DOCUMENT 00 90 00
ADDENDUM

ADDENDUM NO. [2] **Date: February 24, 2021**

RE: WESTERN TECHNICAL COLLEGE
SPARTA PUBLIC SAFETY EXPANSION
11177 COUNTY HWY A
SPARTA, WISCONSIN 54656
HSR PROJECT NO. 20028

This Addendum consists of [5] pages, [1] Revised Bid Form, [1] specification section [21] 30 x 42 drawings and [1] prior product approval.

1 FIRST FLOOR RCP - AREA A
1/8" = 1'-0"

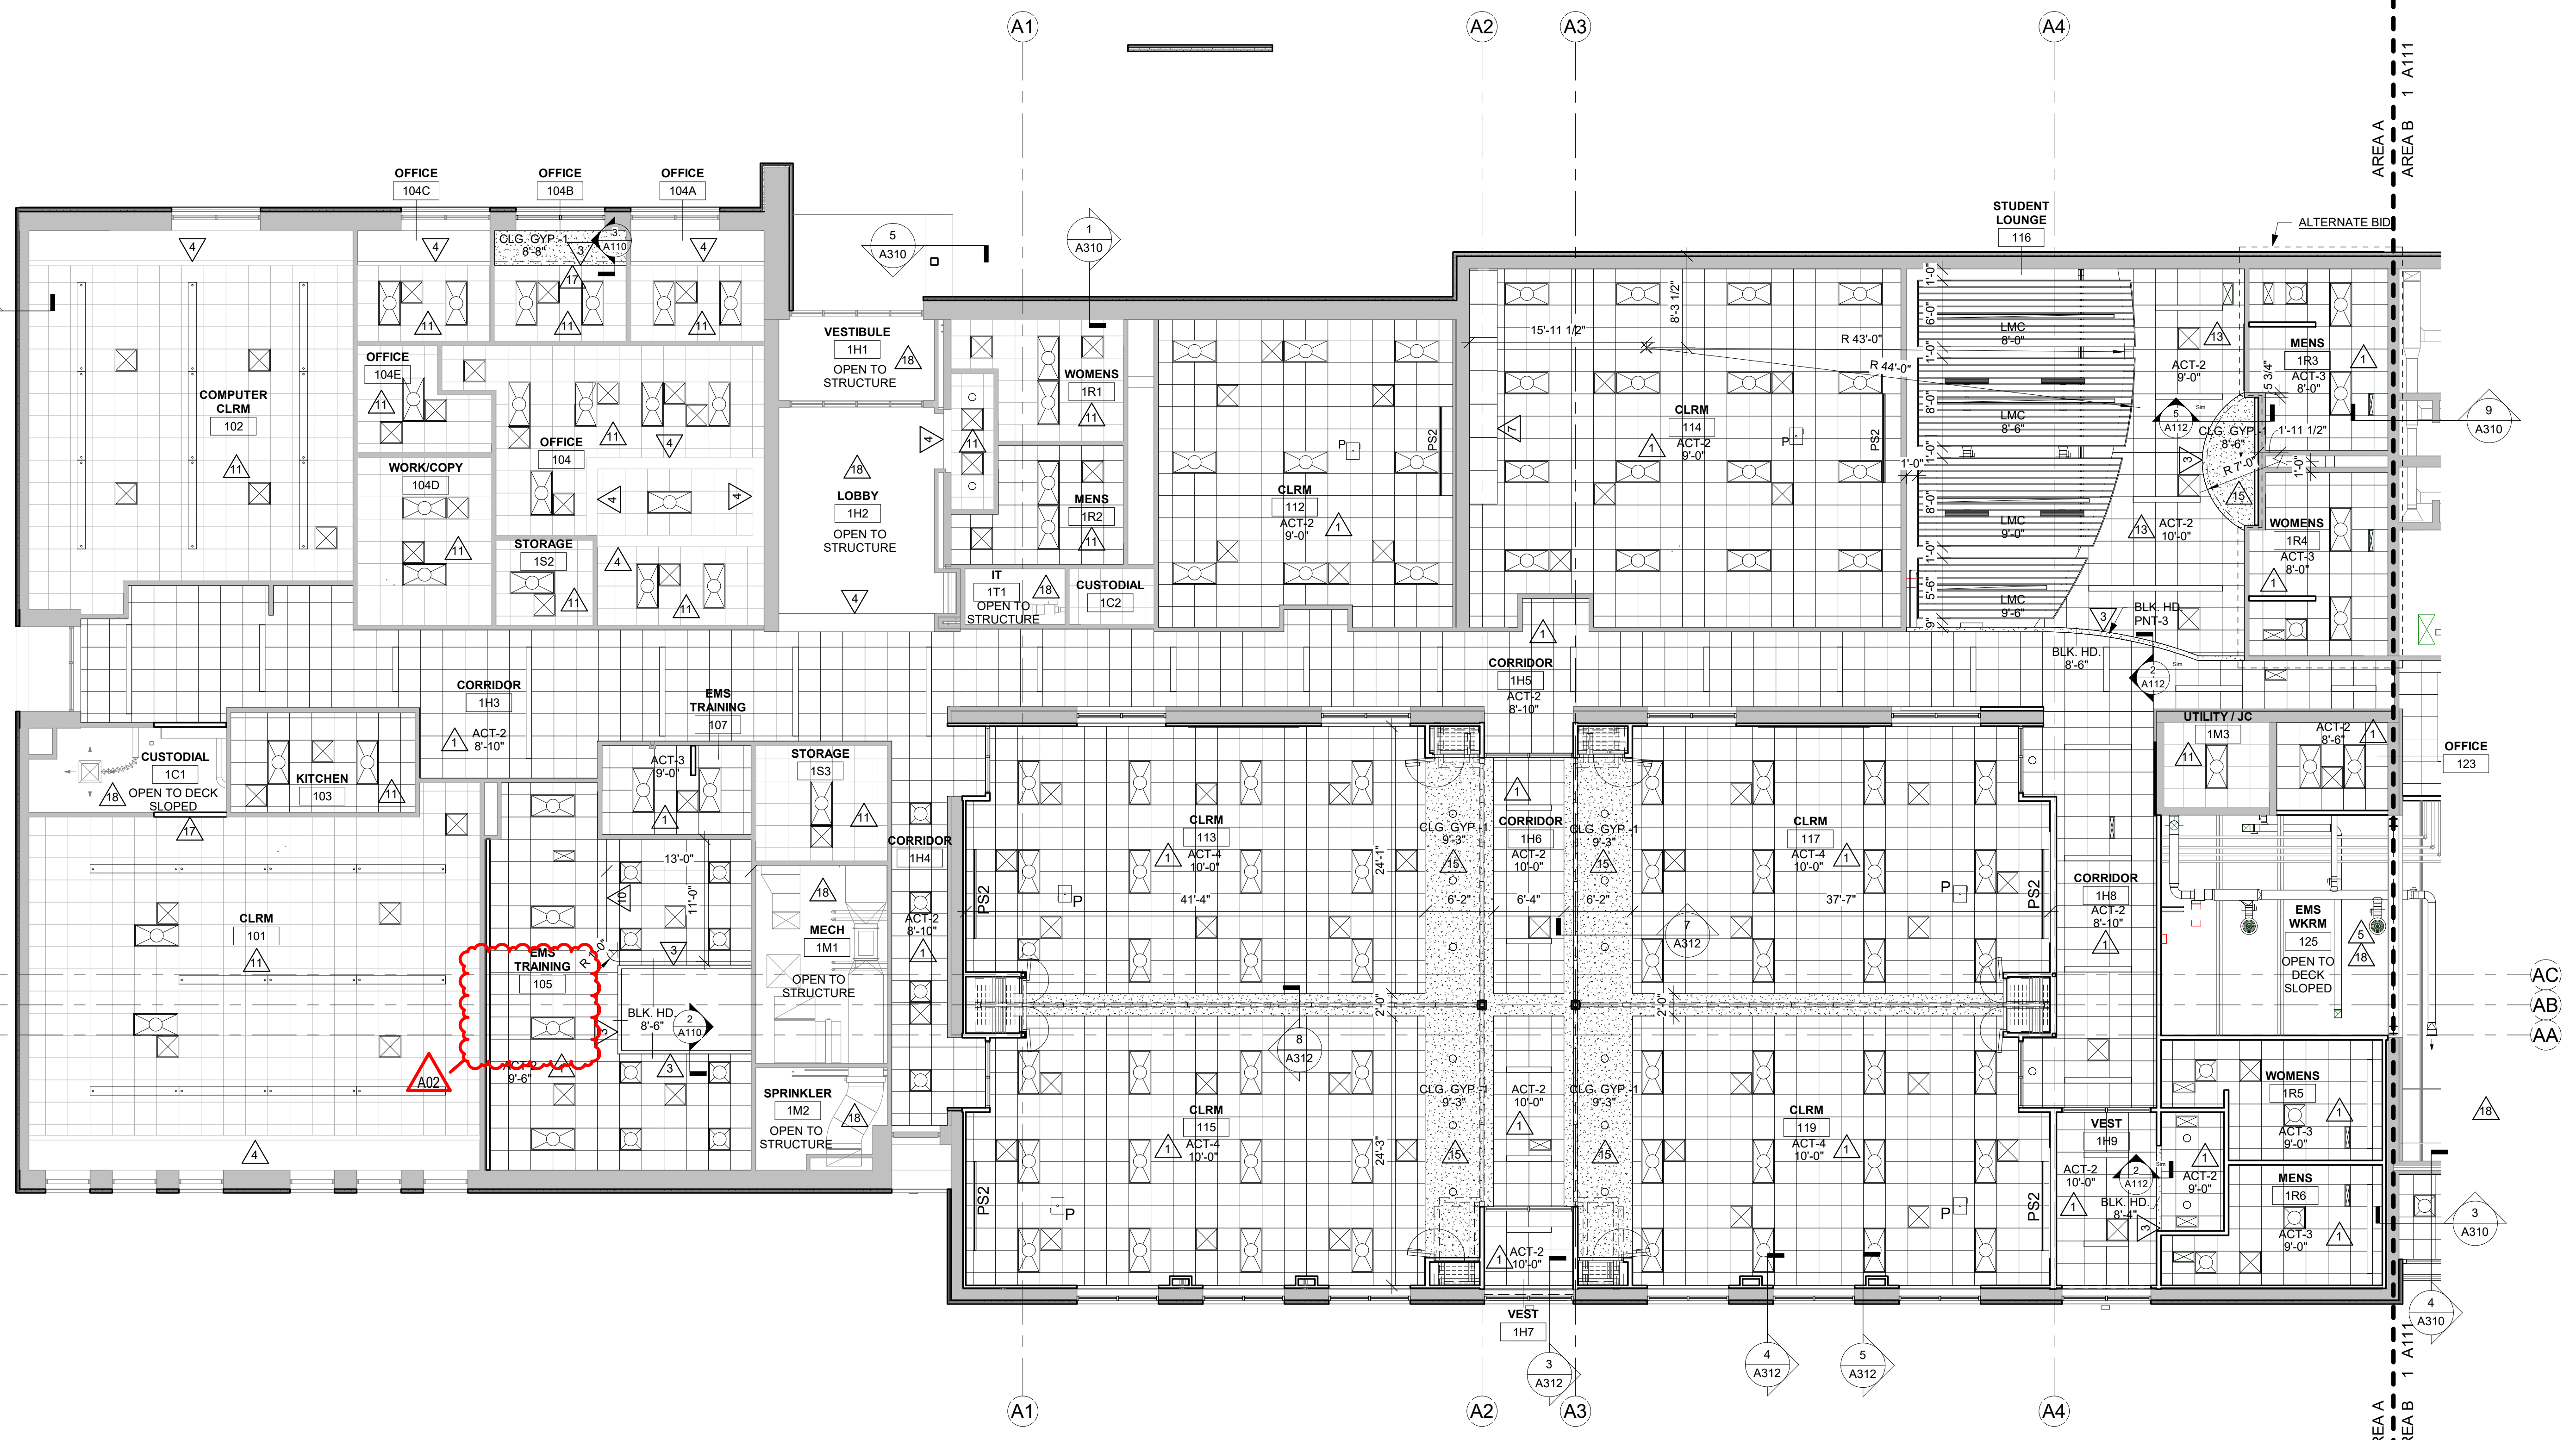
- a. Revisions clouded on Drawing
 - b. Removal of projector from room 105.
19. Sheet A120 ROOF PLAN – AREA A 30 x42 attached hereto
 - a. Revisions clouded on Drawing

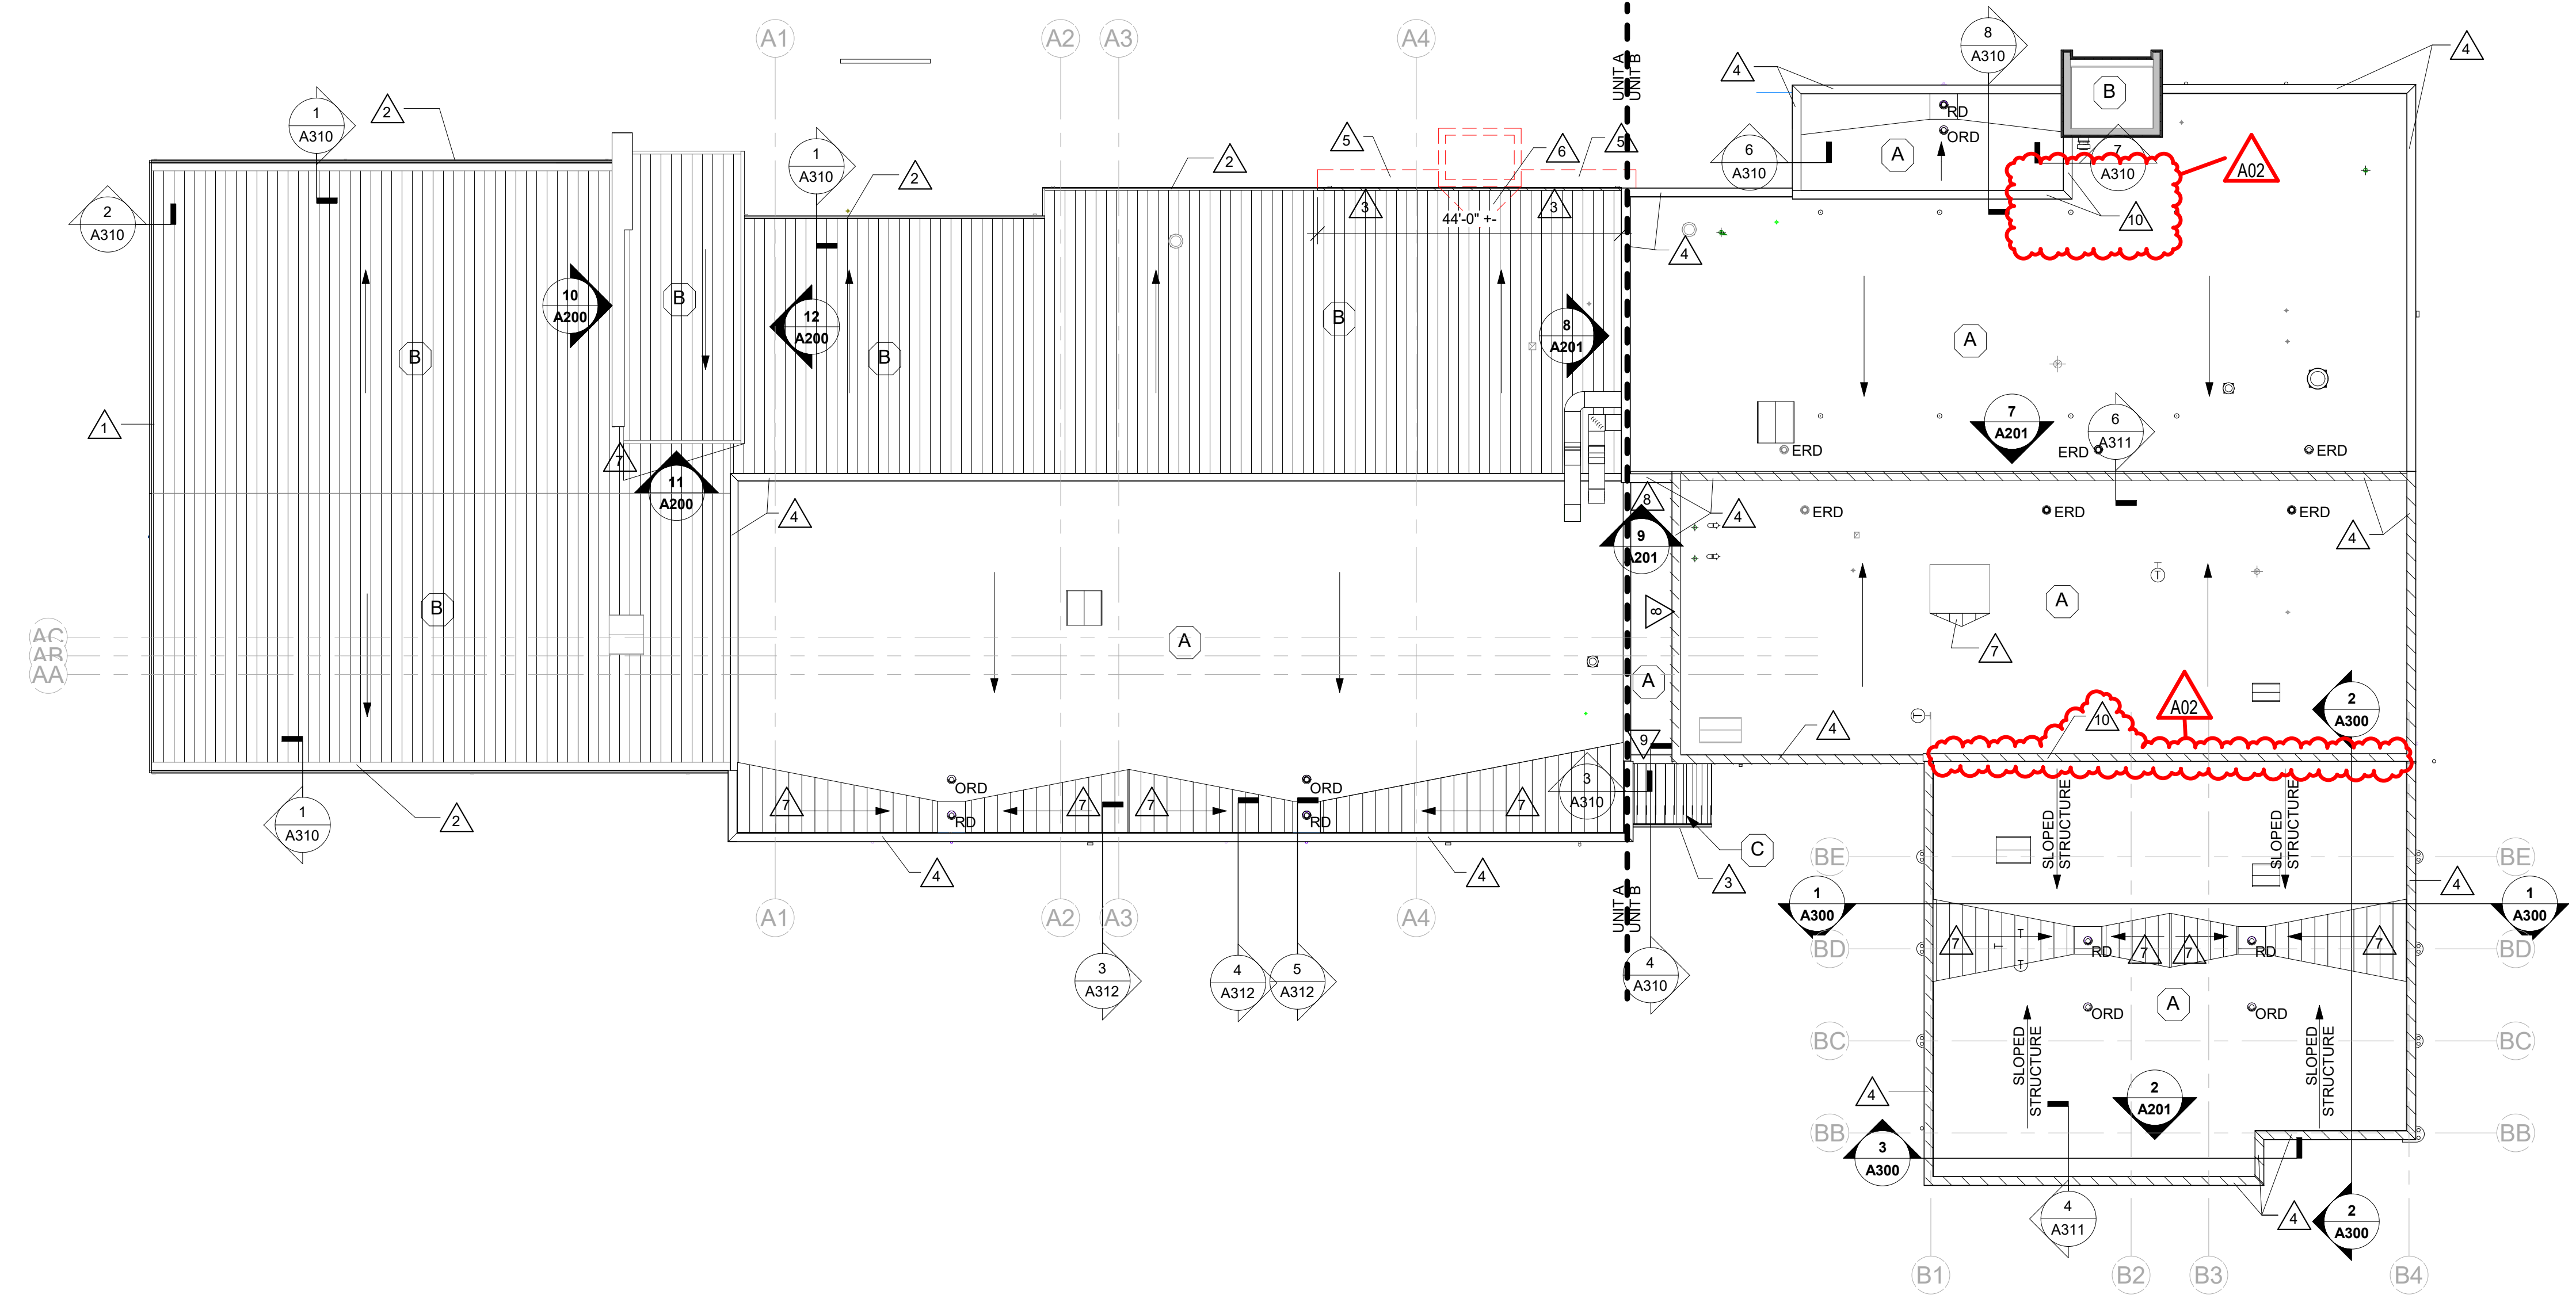
- b. Revised roof plan notes to clarify scope of work.
20. Sheet A210 CASEWORK ELEVATIONS 30 x42 attached hereto
 - a. Revisions clouded on Drawing
 - b. Added under cabinet light to 9A210. Contractor to provide a loose valance.
